**Halton District School Board**

**Addendum No. 1**

**RFT 26-030 Oakville #5 Elementary School & Child Care Facility**

**ADDENDUM NO. 1****Issued January 26, 2026**

DETAIL AT NORTH DRIVEWAY ENTRANCE

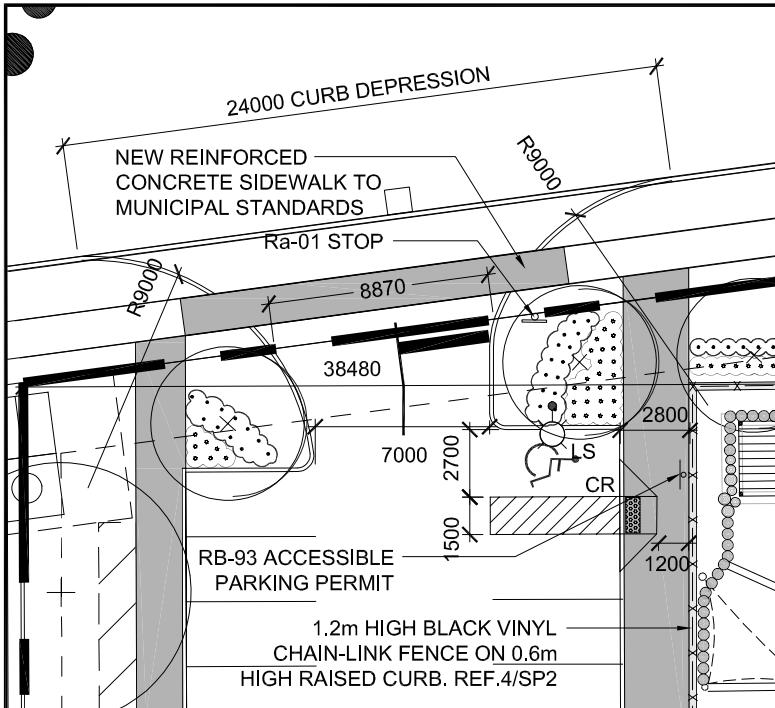
- .1 REVISE: site plan legend annotation for fencing linetype ----O----O---- to read "1.8m HIGH BLACK VINYL CHAINLINK FENCE."
- .2 REVISE the following items per drawing SKA1 dated January 23, 2026 enclosed:
  1. DELETE: 'CR' (Curb Ramp complete with Tactile Indicator) beside accessible street parking along Settlers Road West
  2. ADD: line painting and reinforced concrete pad at accessible street parking along Settlers Road West.
  3. ADD: new reinforced concrete sidewalk to municipal standard replacement and curb depression at site entrance along Settlers Road West.
  4. ADD: new reinforced concrete sidewalk to municipal standard replacement and curb depression at site entrance along Preserve Drive.
  5. ADD: concrete sidewalk dimensions and line painting at accessible street parking along Preserve Drive.

SUNSHADES ON PARTIAL EAST ELEVATION

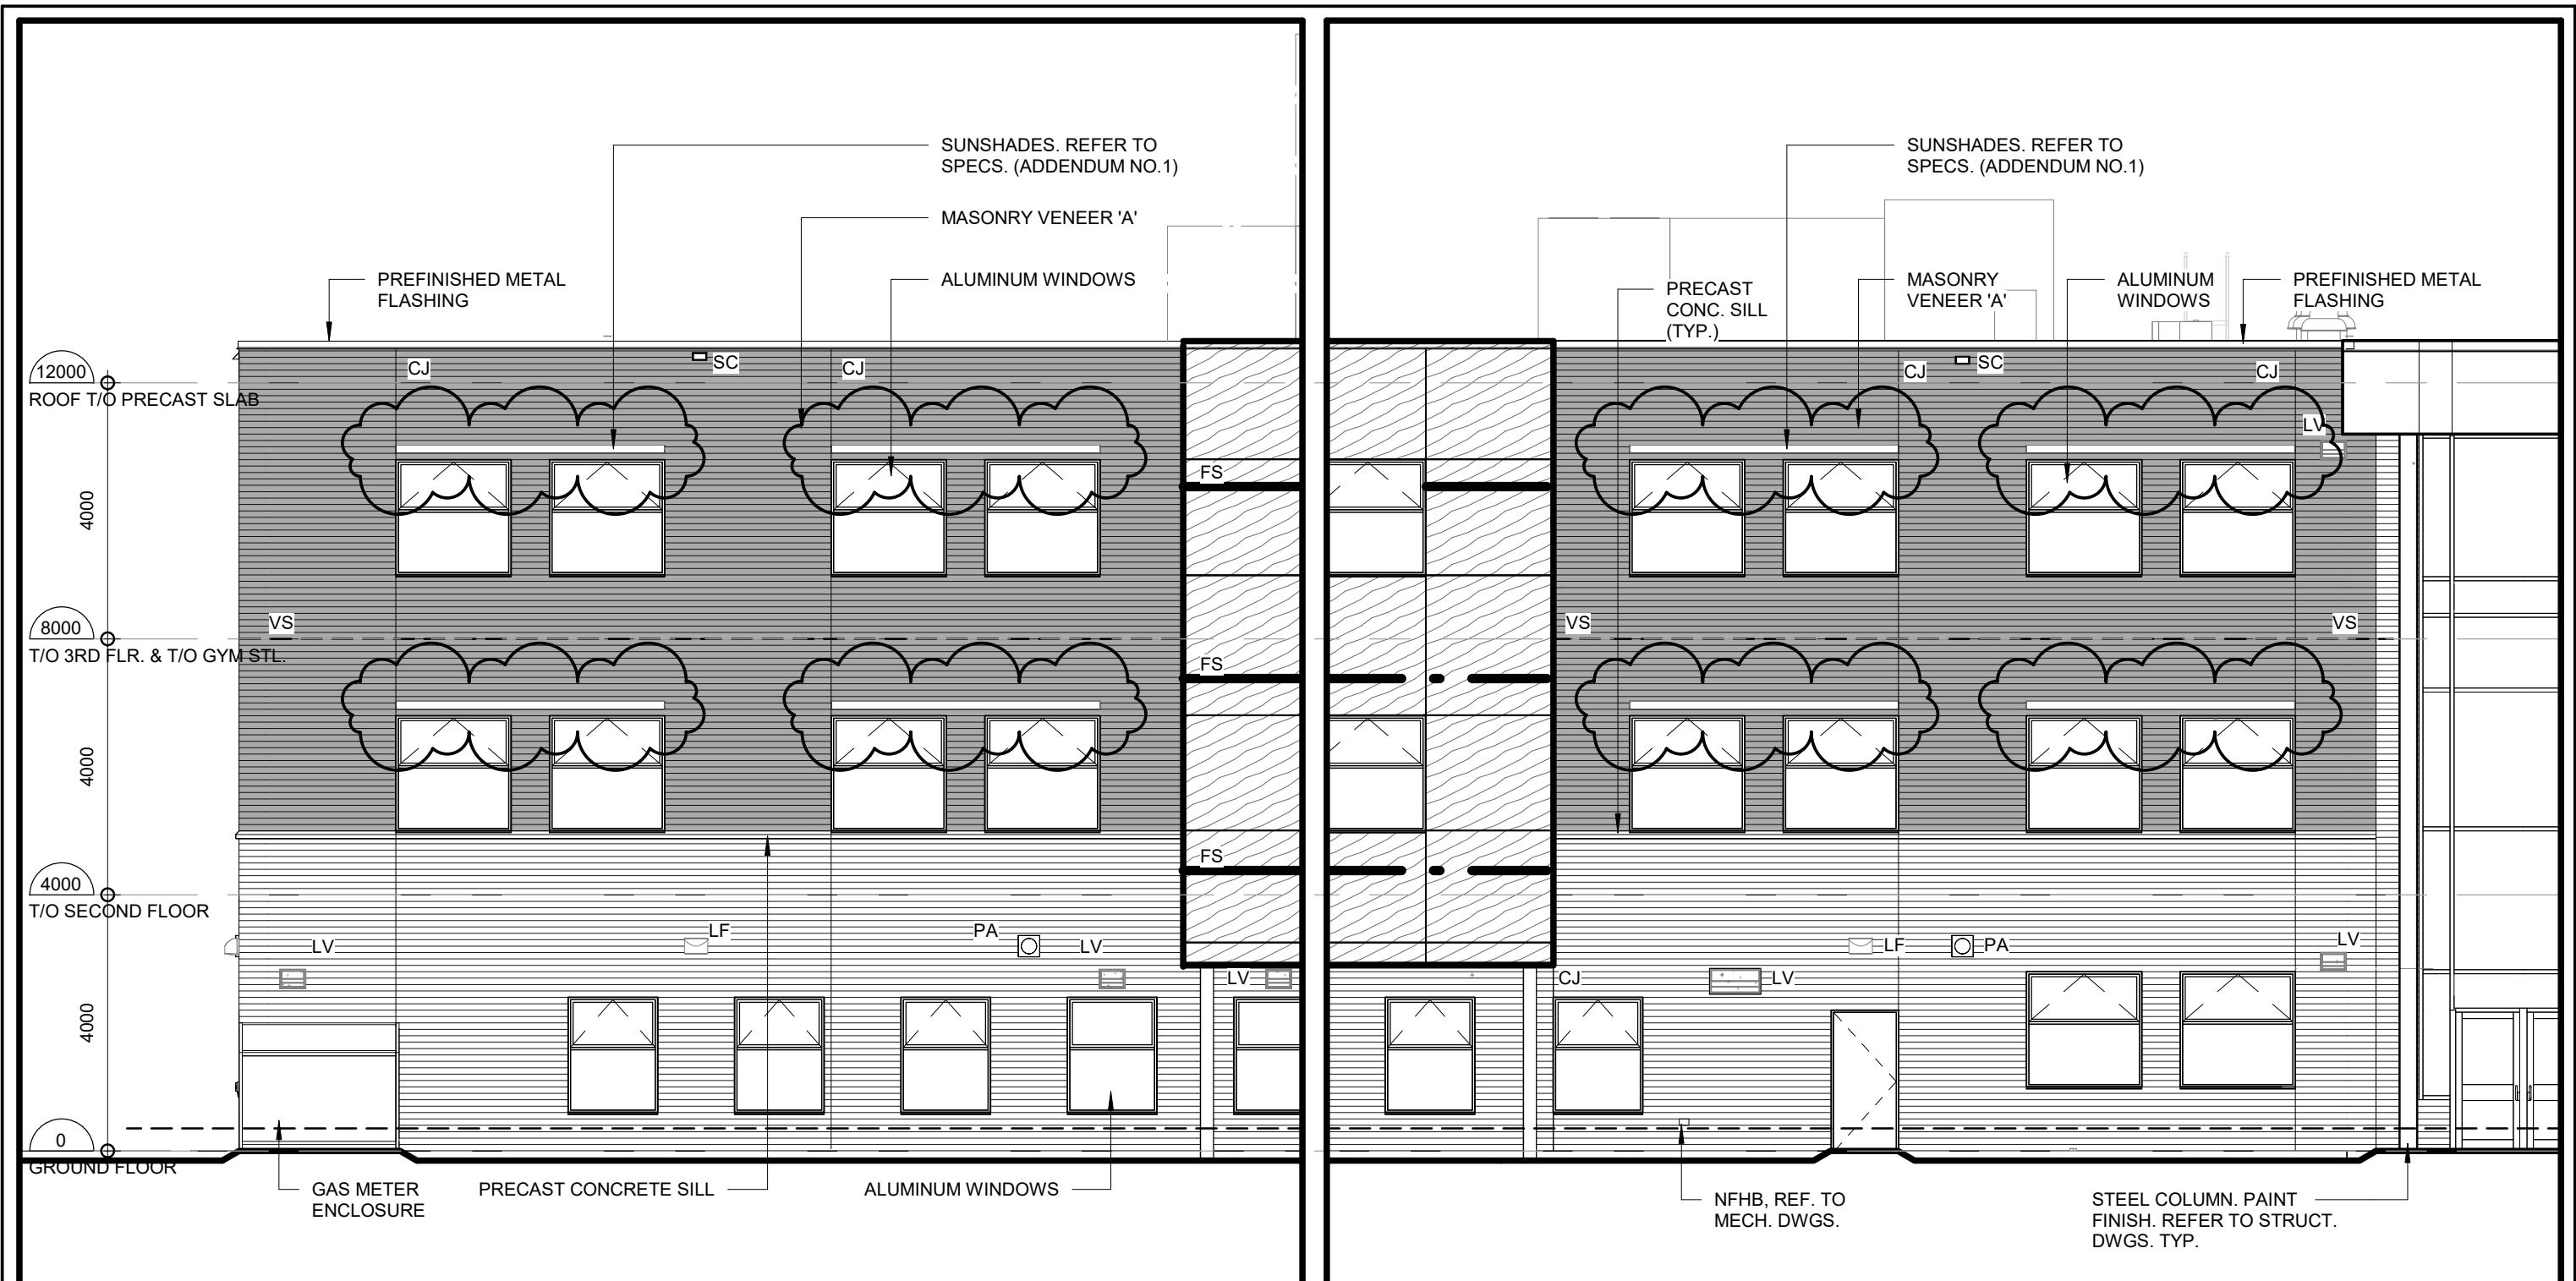
- .1 DELETE: all 11-qty. sunshades on the North Elevation in entirety.
- .2 ADD: a total of 8-qty. sunshades on the East Elevation above the series of classrooms windows on the second and third floor as illustrated on drawing SKA2 Sunshades on Partial East Elevation dated January 23, 2026 enclosed.
- .3 CLARIFICATION: Follow detail 9/A16 Window Section Detail @ Sunshades for above sunshade revision.
